37/3-93GG 7063 Carroll Avenue
Takoma Park Historic District

**Mr. Robert Hubbard
Hearing Examiner
Montgomery County Department
of Environmental Protection
250 Hungerford Drive
Rockville, MD 20850****SUBJECT: 7063 Carroll Avenue--Parking Waiver Application**

HISTORIC PRESERVATION COMMISSION STAFF REPORT

Address: 7063 Carroll Avenue Meeting Date: 11/17/93
Resource: Takoma Park Historic District Review: HAWP/Alteration
Case Number: 37/3-93GG Tax Credit: No
Public Notice: 11/3/93 Report Date: 11/10/93
Applicant: Frank Calcara Staff: Nancy Witherell
PROPOSAL: Parking lot/lighting/
site alterations RECOMMEND: Approve with
condition

PROPOSED CONDITIONS

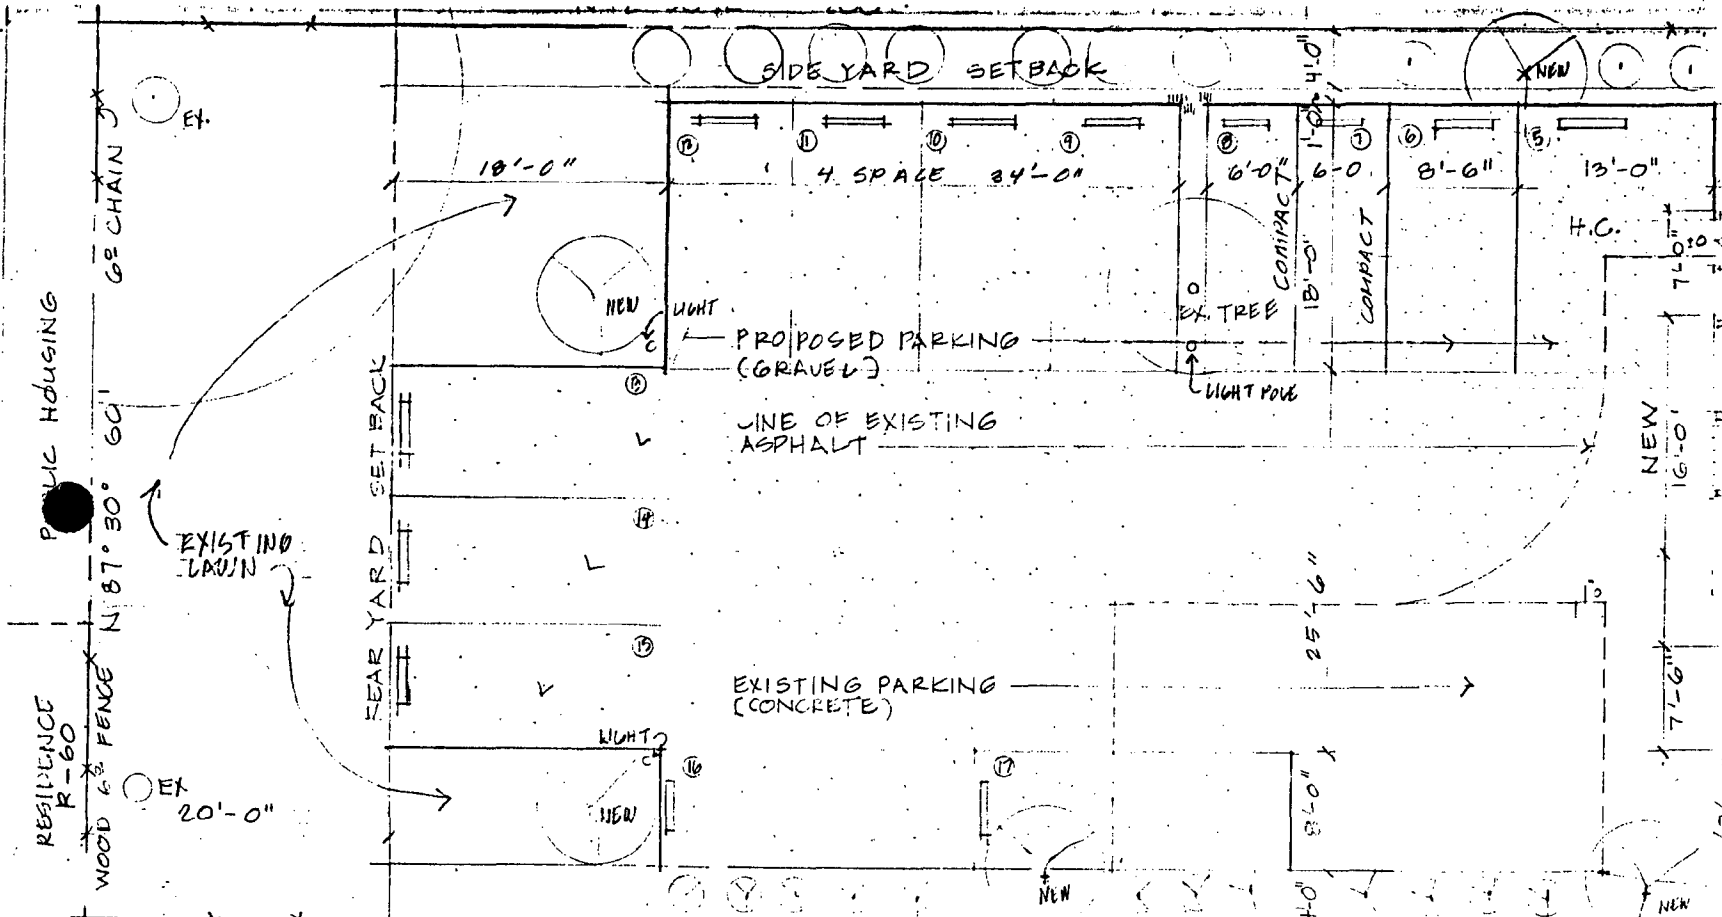
In the staff's judgment, the applicant has tried to mitigate these effects through design. For example, note the new light pole at the rear corners--the applicant proposes planting new trees behind the poles in order to screen the light from adjacent properties. And the lawn areas themselves are extended at the rear corners.

The staff would recommend two conditions and offer two suggestions. The first condition is that a planting scheme be presented for approval at the staff level. The plantings should provide a sufficient buffer at the rear corner adjacent to the residential lot to mitigate the effects of light and noise.

The second condition is that the HPC direct the applicant to find additional parking spaces off site so that the area behind the building can have a rear yard setback in excess of the minimum requirement. While the zoning code requires 20', which is what the applicant has provided, the staff believes the applicant should make a good faith effort to reduce the number of parking spaces on site, since the effects of the restaurant business will be felt most keenly at night, when a residential owner might expect the quiet enjoyment of his property.

The two suggestions are: 1) that the fence be raised to full allowable height (78") along the rear property line as part of a landscape buffer plan; and 2) that a lighting fixture more neutral in style be found.

The staff recommends that the proposed application be found generally acceptable, but only on the conditions that 1) a landscape buffer plan be submitted for approval by the staff; and 2) that the number of on-site parking spaces be reduced by approximately 3 so that a larger and more substantial planted buffer be provided to the residential neighbor.
